## DEVELOPMENT HEARING OFFICER (DHO)

#### **PR-2019-003169**

SD-2023-00132 – PRELIMINARY PLAT

REQUEST: THE SUBDIVISION IS A REPLAT OF TRACT INTO 78 LOTS AND 2 TRACTS.

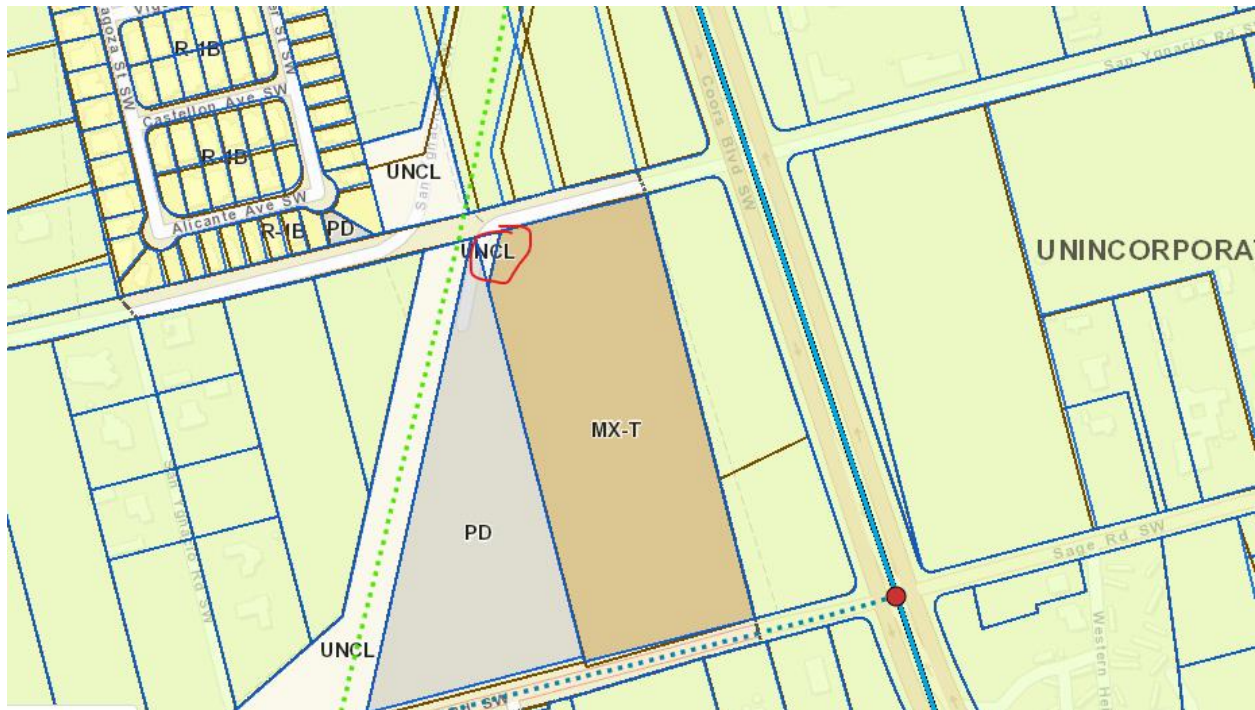
There is proposed trail along the Amole del Norte Diversion Channel which runs immediately adjacent to a property in the NW corner of the subject site. The triangular piece adjacent to the site is owned by the City of Albuquerque. A private access to this property through Lots 29 or 30, would help create a short 80 ft off-street travel distance to future trail as opposed to an existing 750 ft connection point on the southside along Sage Rd. Though not required, this type of access within the proposed development would further many of the purposes listed in IDO Section 14-16-5-3 ACCESS AND CONNECTIVITY. The northern portion of the subject site is not located within a 10-minute walk (1/2 mile) to a park or accessible green space, so looking towards the future – this access could provide great accessibility for residents of the development to more easily and safely access passive recreation and/or multi-modal opportunities for commuting and daily errands/tasks.
